STAFF REPORT
COMMUNITY DEVELOPMENT DEPARTMENT

HEARING DATE: 11/3/2022
 TO: Planning & Zoning Commission
 FROM: Joe Dodson, Associate Planner
 208-884-5533
 SUBJECT: H-2022-0059
 Alden Ridge Subdivision
 LOCATION: 6870 N. Pollard Lane and the three (3) parcels to the north and east, directly east of SH 16 and directly south of the Phyllis Canal at the northern edge of the Meridian area of City impact, in the NE 1/4 of the SW 1/4 of Section 21, Township 4N, Range 1W.

EXHIBIT MAP

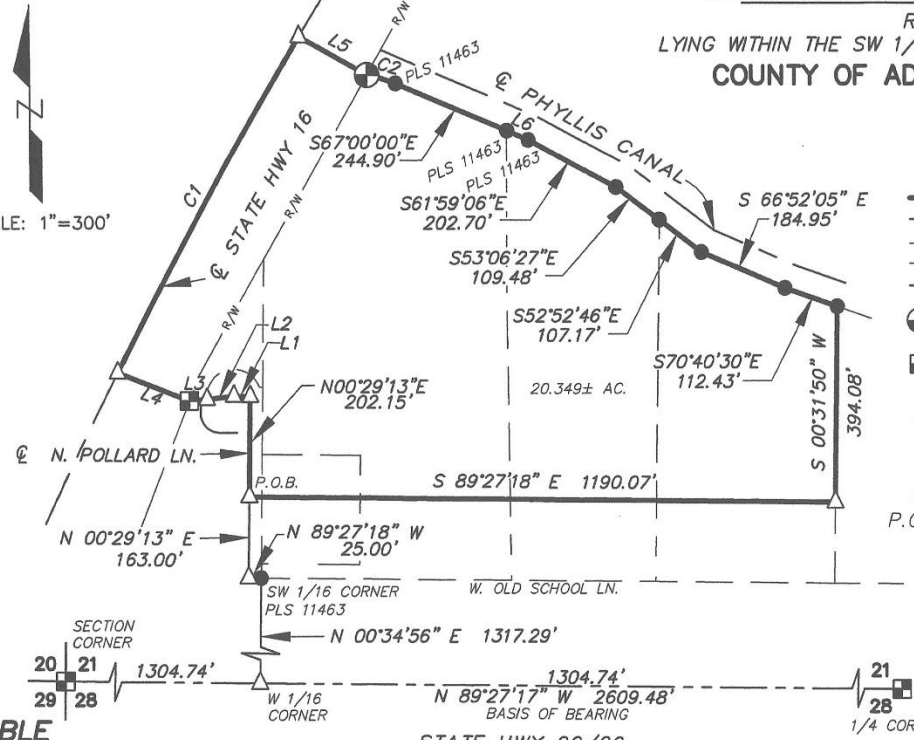
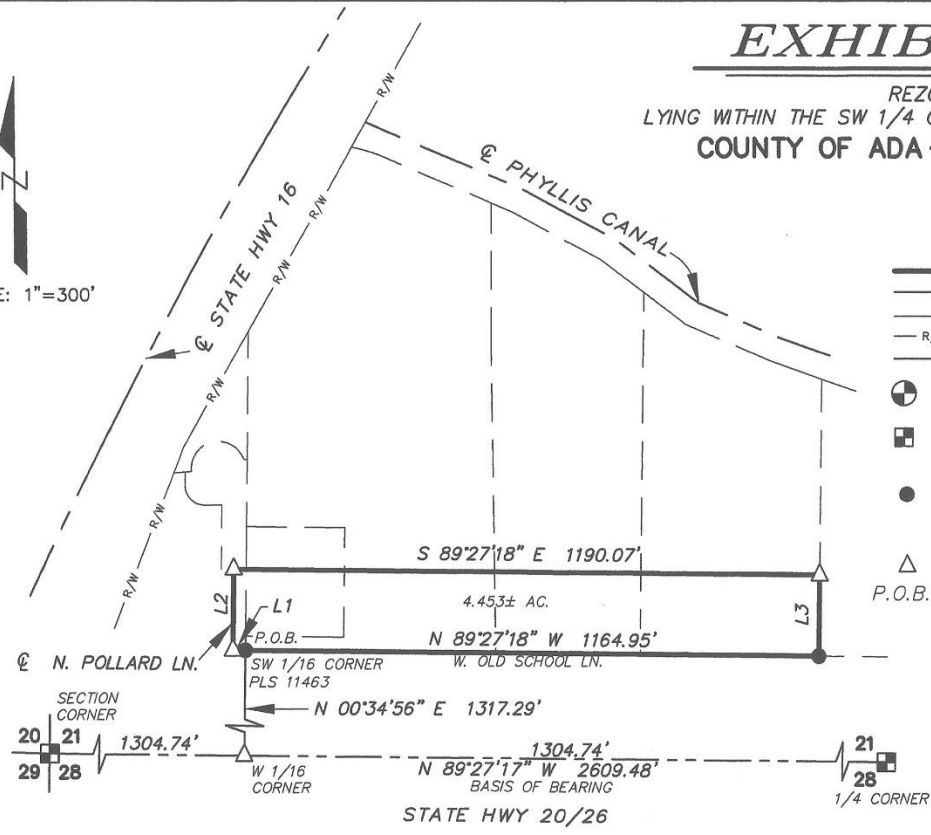
13. Prior to the City Council hearing, submit conceptual building elevations for the R-8 building lots.
14. The submitted R-4 & R-8 zoning legal descriptions and exhibit maps are mislabeled as Rezone exhibits; prior to the City Council hearing, the applicant shall provide revised legal descriptions and exhibit maps noting these to be "Zoning" instead of "Rezone."

C. Landscape Plans (date: 7/18/2022)

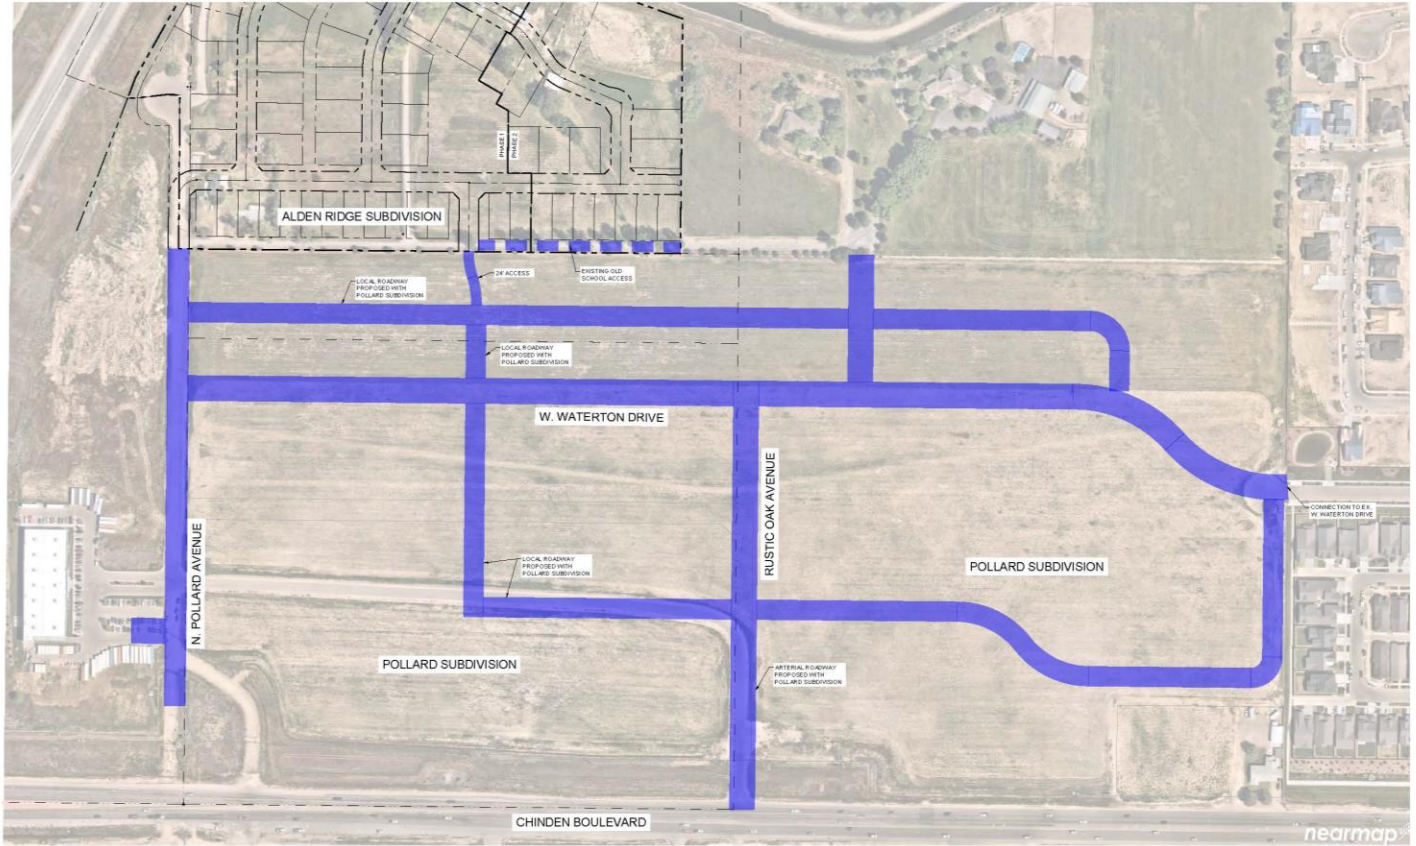
As discussed, the Applicant has proposed linear open space and micro-paths around and through the development. These areas should be landscaped in accord with UDC 11-3B-12 with trees at least every 100 linear feet and include other vegetative ground cover. According to the submitted landscape plans, the Applicant is proposing trees in excess of code requirements with sod throughout; additional vegetative ground cover is required in accord with UDC 11-3B-12. The Applicant should revise the landscape plans to depict the required revisions with the relevant final plat applications.

According to the submitted landscape plans, the Applicant is proposing two types of fencing throughout the site, vinyl privacy fencing and vinyl semi-privacy fencing, in addition to proposing a masonry wall at the top of the berm along the west boundary adjacent to SH 16. Staff finds the locations of all of the proposed fencing to comply with UDC requirements. However, the type of semi-private vinyl fencing shown within the submitted landscape plans do not comply with the exhibits depicted with the UDC that requires the solid portion to be no more than 4 feet in height and the top 2 feet must be at least 80% open-vision. The Applicant is required to revise this type of fencing shown on the submitted plans with future final plat applications.

In addition, the Applicant is proposing a berm/wall combination along the SH 16 frontage at the northwest property boundary and notes the wall to be approximately 4 feet in height with a 4-foot to 5-foot tall berm; therefore, the combined height of the berm/wall is approximately 8-9 feet in height. UDC 11-3H-4, development along state highways, is applicable in this area of the project because of the frontage with SH 16. Code requires the berm/wall combination to be a minimum of 10 feet above the centerline of the highway. Therefore, the applicant should revise the height of the proposed berm and wall to comply with the UDC.

3. The landscape plan included in Section VII.C, dated July 18, 2022, shall be revised as follows prior to submitting for Final Plat approval:
 - a. Depict additional vegetative ground cover in all linear open space consistent with UDC 11-3B-12.

- b. Revise the design of the semi-private open vision fencing proposed to be consistent with Figure 1 in UDC 11-3A-7.
 - c. Per UDC 11-3H-4, revise the height of the berm/wall combination to be at least 10 feet above the centerline of SH 16 and depict this height within the exhibit on the Landscape Plans.
